Access Compliance Report

Public Rights-of-Way

(Curb Ramps)

Intersection ID: 14314	Main Street: E_TREMONT_AV	Cross Street: SOUTH_BV	Location: NW
ADA ID: 31A5E29CF5FF	Ramp Type: Perp	Initial Pass/Fail: Fail	Overall Compliance: No
		Severity Score: 12.5

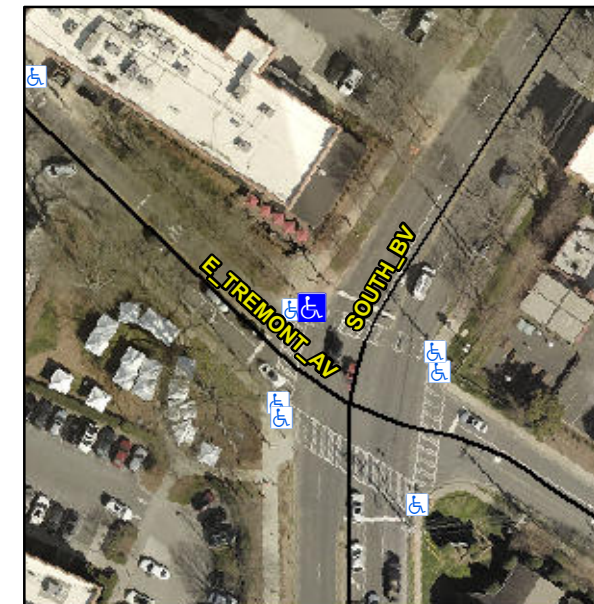
R304.2.2

Compliance	Description	Data	Compliance	Description	Data
N/A	Ramp Length (in)	71.0	No	Ramp Slope (%)	8.7
Yes	Ramp Width (in)	48.0	Yes	Ramp XSlope (%)	1.8
N/A	Flare Type LT	N/A	N/A	Flare Type RT	N/A
N/A	Flare Slope LT (%)	N/A	N/A	Flare Slope RT (%)	N/A
N/A	Flare Traversable LT?	N/A	N/A	Flare Traversable RT?	N/A
N/A	Landing Length (in)	N/A	N/A	DWS Provided?	N/A
N/A	Landing Width (in)	N/A	N/A	DWS Contrast?	N/A
N/A	Landing Slope (%)	N/A	N/A	DWS Length (in)	N/A
N/A	Landing X Slope (%)	N/A	N/A	DWS Full Width?	N/A
N/A	Landing Curb? (Y/N)	N/A	N/A	DWS Offset (in)	N/A
N/A	Shared Landing?	N/A			
N/A	Gutter Ponding?	N/A	N/A	Gutter Slope (%)	N/A
N/A	Gutter Lip Ht (in)	N/A	N/A	Gutter X Slope (%)	N/A
N/A	Painted X Walk1?	Yes	N/A	Painted X Walk2?	N/A
	X Walk 1 Direction	To SE		X Walk 2 Direction	N/A
N/A	X Walk 1 Width (in)	114.0	N/A	X Walk 2 Width (in)	N/A
	X Walk 1 Slope (%)	4.2		X Walk 2 Slope (%)	N/A
	X Walk 1 X Slope (%)	3.8		X Walk 2 X Slope (%)	N/A

Remove & Replace Entire Ramp.
